COLBEA ENTERPRISES, LLC SITE PLAN

SP# 09-23

STAFF REPORT

September 11, 2024

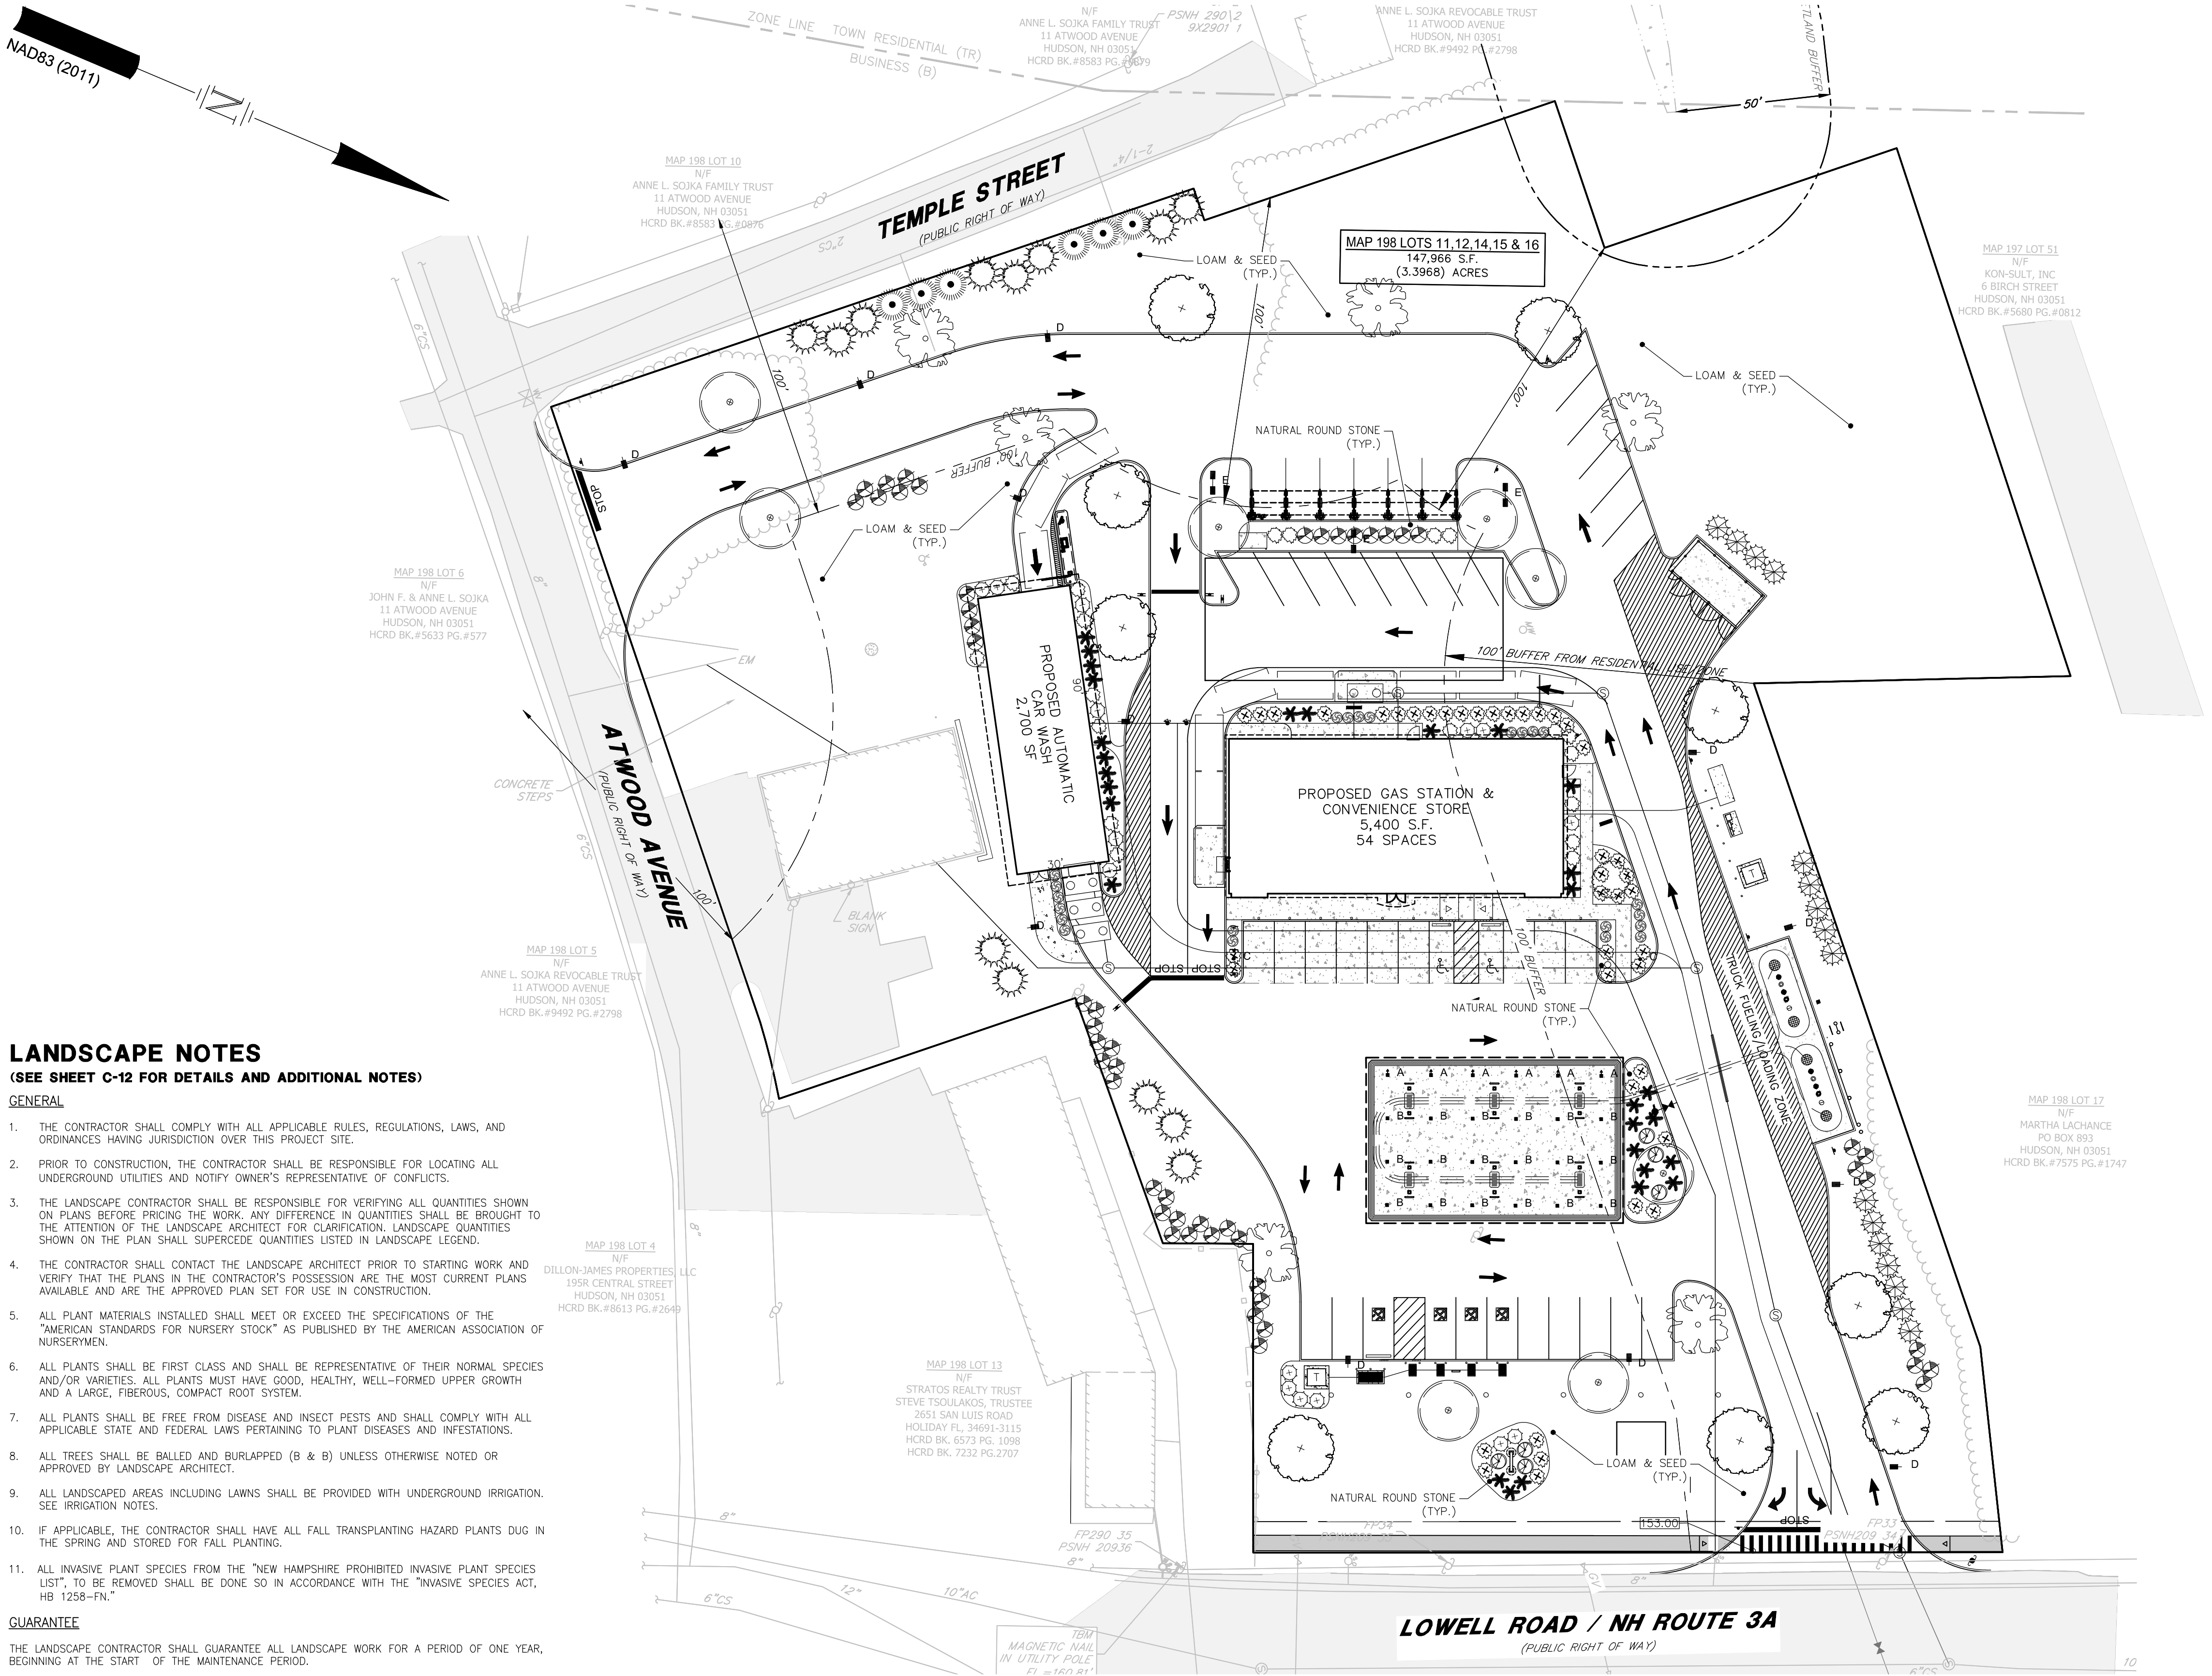
- i. *The referenced callout on Sheet C-08 has been revised from C-04 to C-05.*
- j. HR 275-.9.E & 276-13. There are several drainage crossings of the sewer pipe between SMH-03 and SMH-04. This run of sewer pipe is not shown on a sewer profile. The applicant should confirm that there are no conflicts between drainage and sewer in this area and that there is adequate separation between these utilities.

- i. *A sewer profile for the segment between SMH-03 and SMH-04 has been developed and is included on Sheet C-10b.*
- k. HR 275-.9.E & 276-13. The proposed underground electric line conflicts with several stormwater features within the site. The applicant should review and adjust the proposed UGE locations.

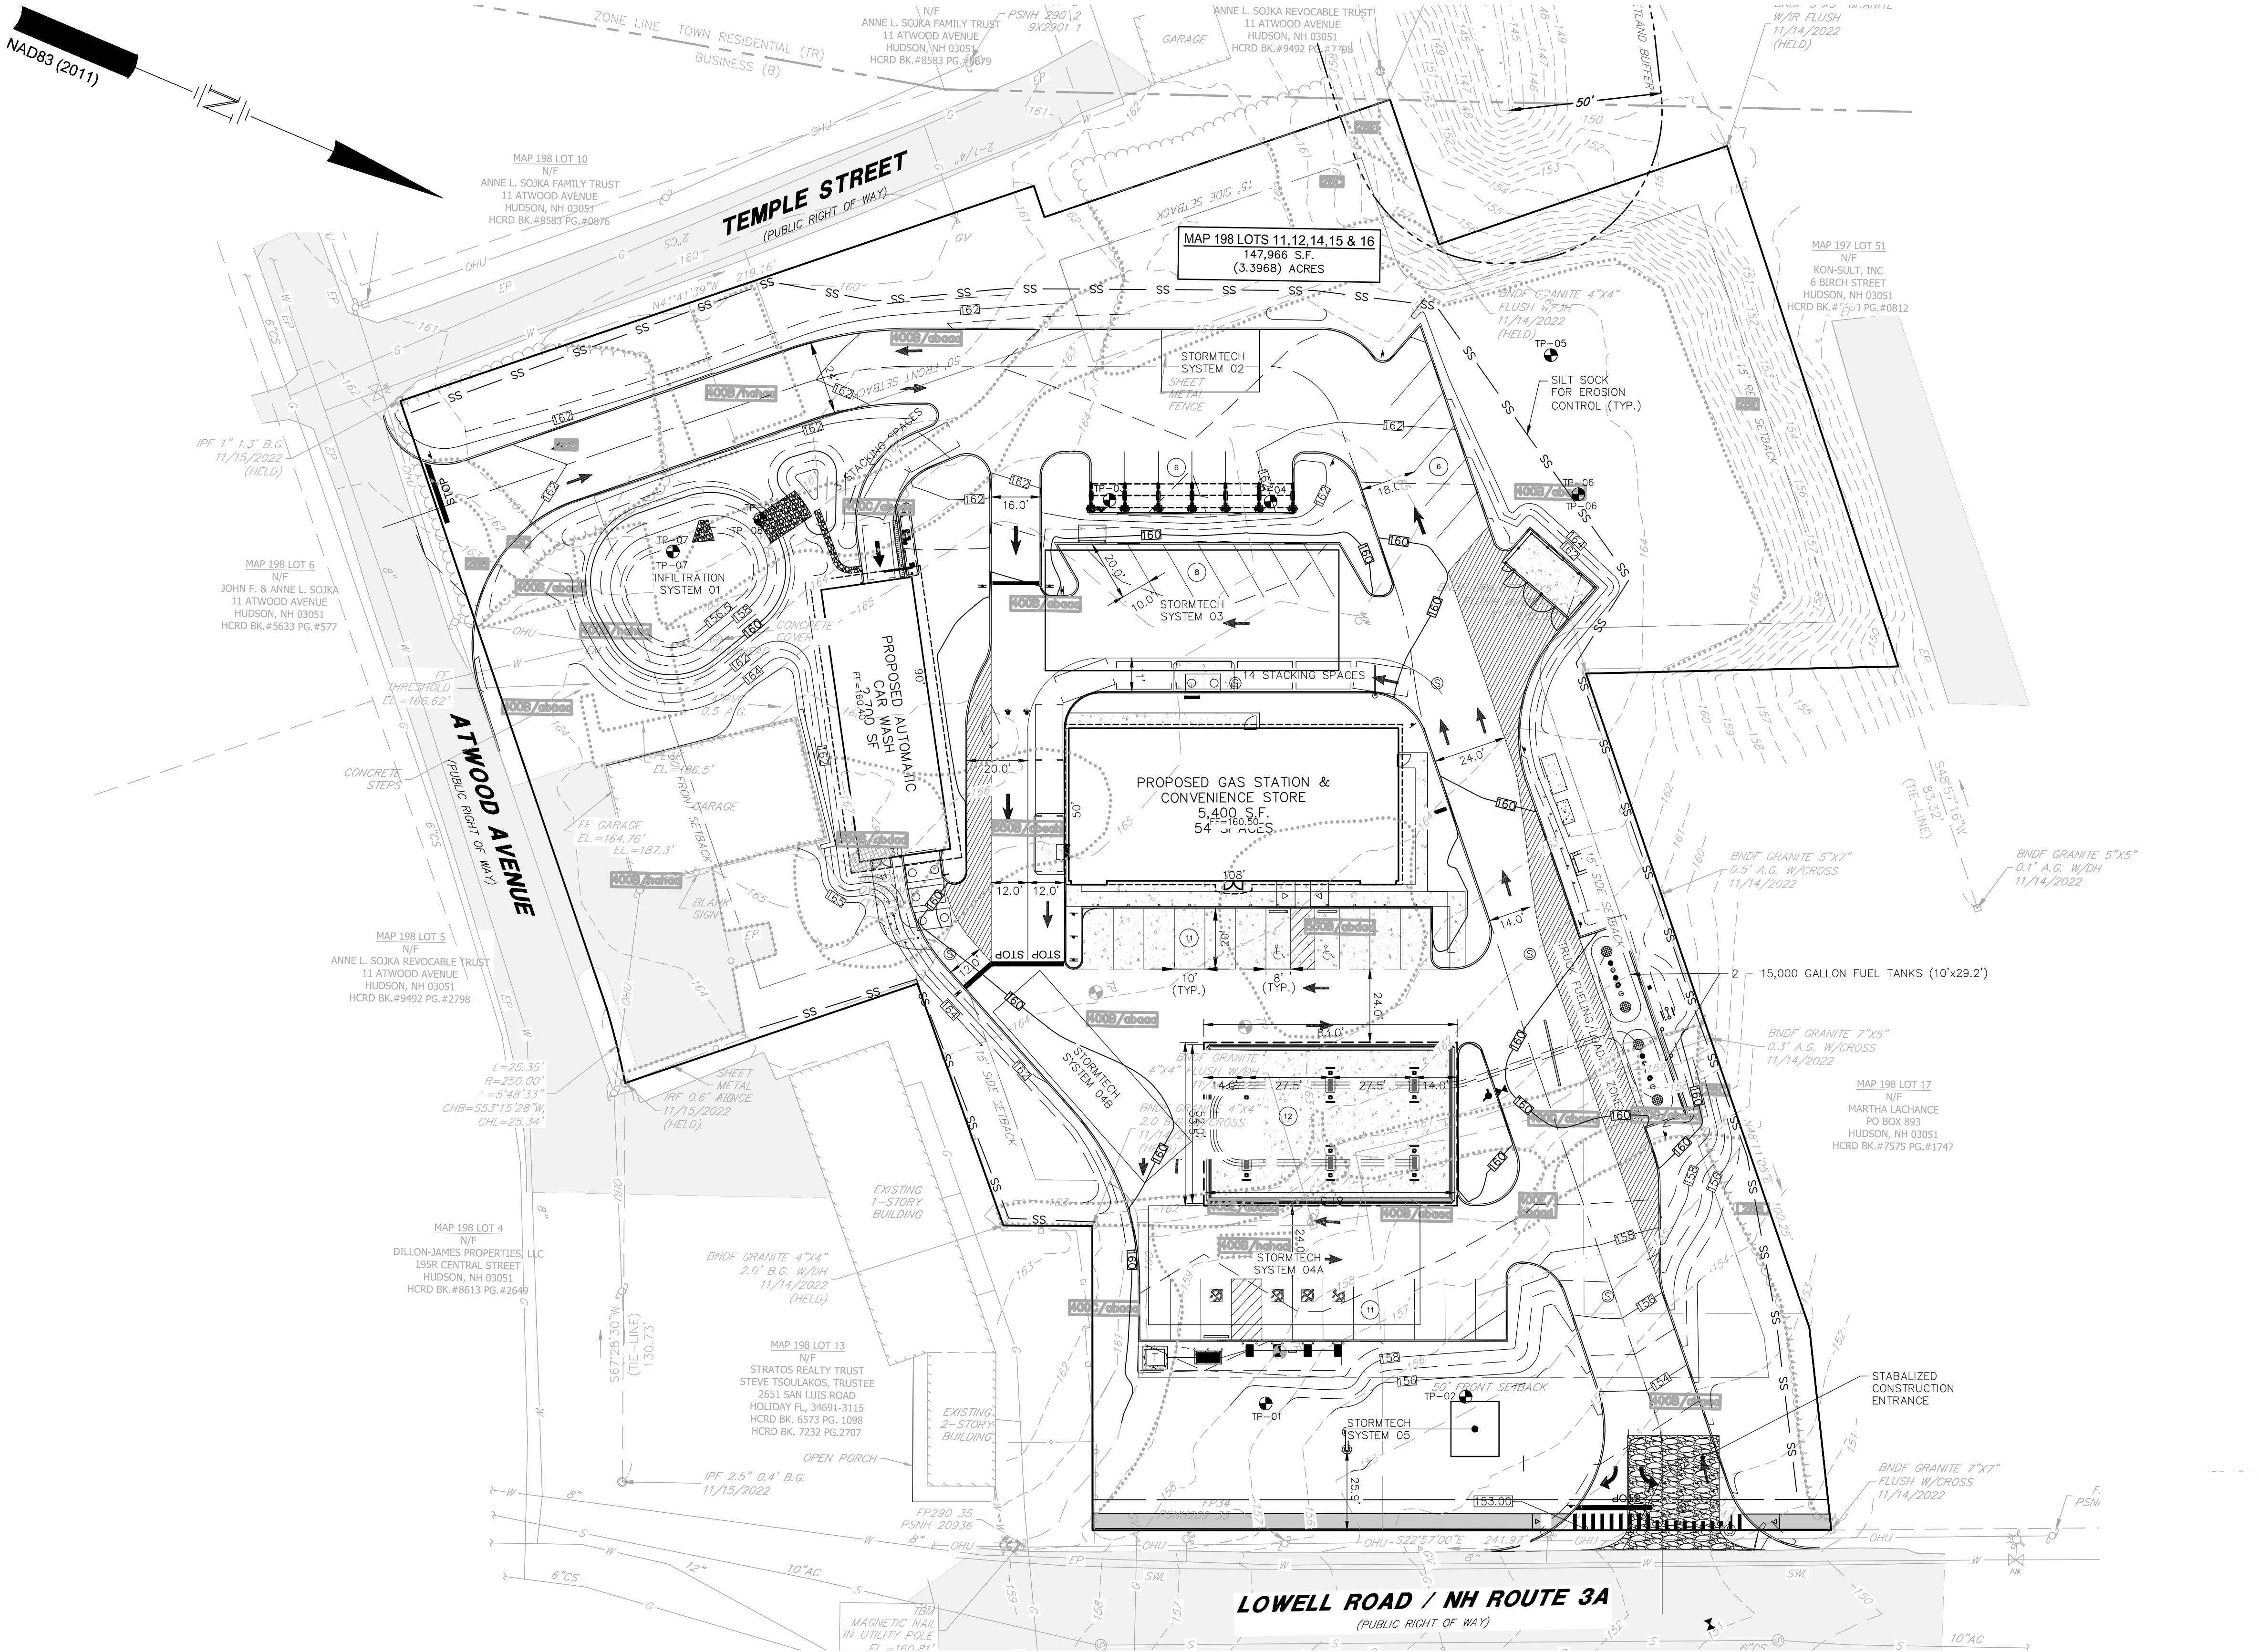
- a. The applicant should show the proposed location for the stabilized construction entrance on the plan set.
 - i. *The stabilized construction entrance has been added to Sheet C-13.*
- b. The applicant has noted that the Town of Hudson shall reserve the right to require any additional erosion control measures as needed.
 - i. *Noted. No response required.*
